MultiPlus-II 8kVA & 10kVA internal AC fuse replacement

Applies to MultiPlus-II 48V 8000 & 10000 - 230V

1. Introduction

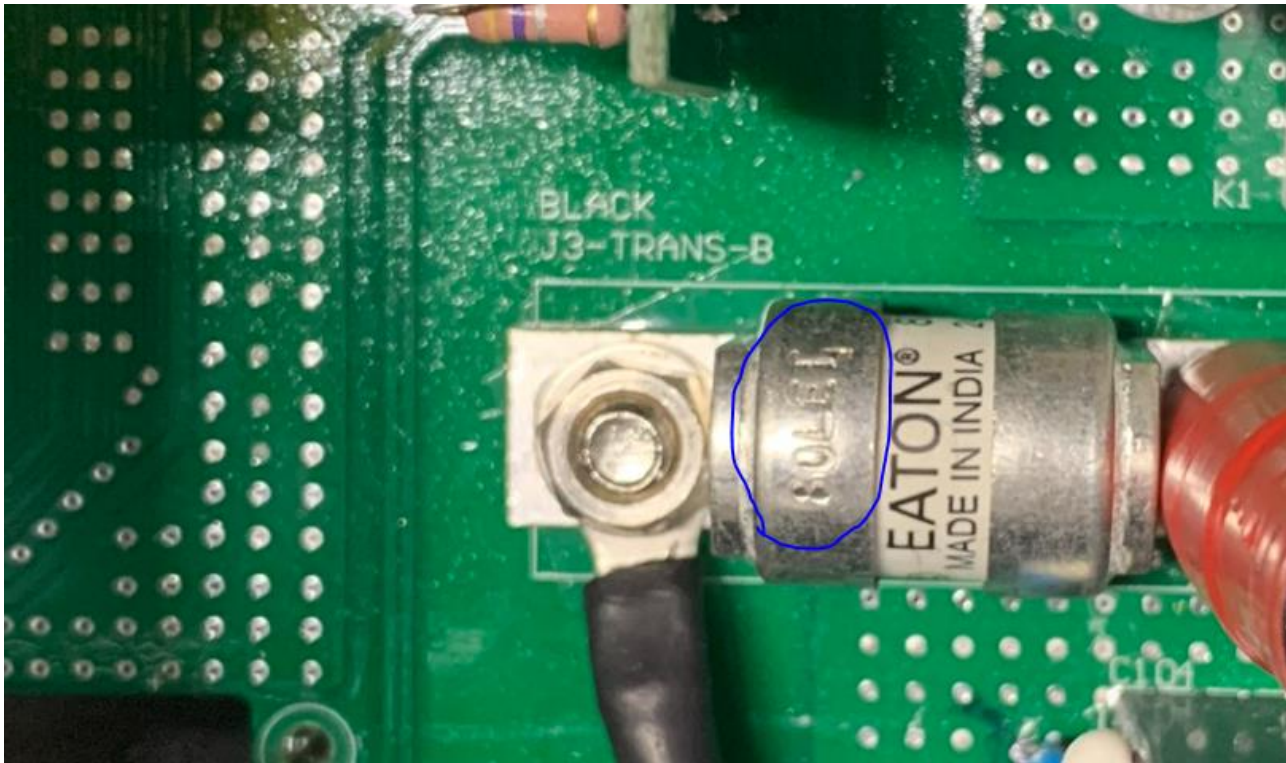
When this fuse is blown, the unit will in a continuous cycle start, (falsely) detect an overload, and switch off signalling overload, and restart again.

On VRM this looks like this:

To double check, use a multimeter to measure the resistance between the AC OUT-1 L and N terminals.

- If the multimeter reads (near to) '0' Ohm; the internal AC fuse is OK.
- If the multimeter reads Open or 'OL'; the internal AC fuse is blown and needs to be replaced.

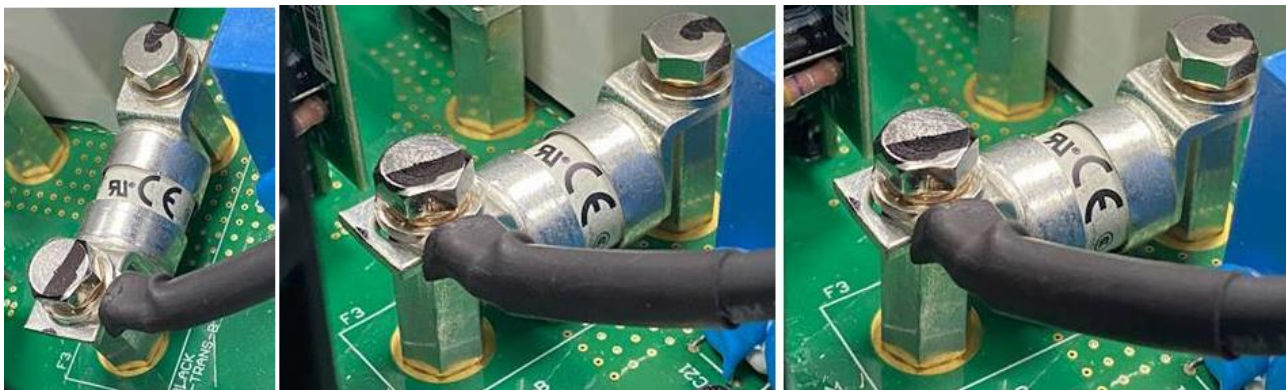
When mounted like in this first picture, the rating can be seen impressed in the metal part on the left:

Solution in case the socket doesn't fit on the nut

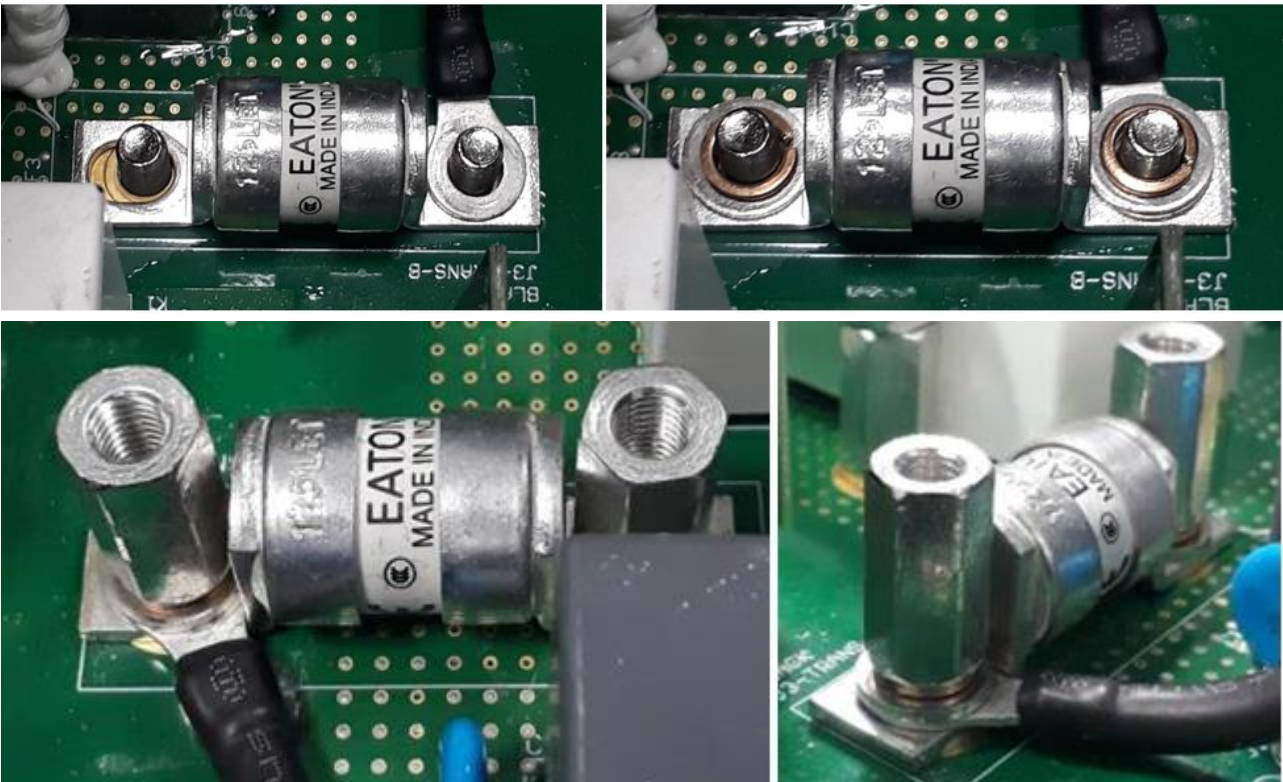
There is a variance in the 125A fuse body dimension that can lead to the socket not fitting properly on the nut.

When using the 125LET Eaton fuse you probably will observe this obstruction encircled in red in below photo.

To avoid that fitment issue, use a coupling nut M6x20 (BN), washers (BN), bolts (BN) and spring washers (PBZ) as shown in below photo. These can be supplied by Victron Almere along with the fuses.

WARNING: as these coupling nuts are conducting high current, it is important that they are made of the proper material (Brass-Nickel), and that the proper torque is applied 6 Nm
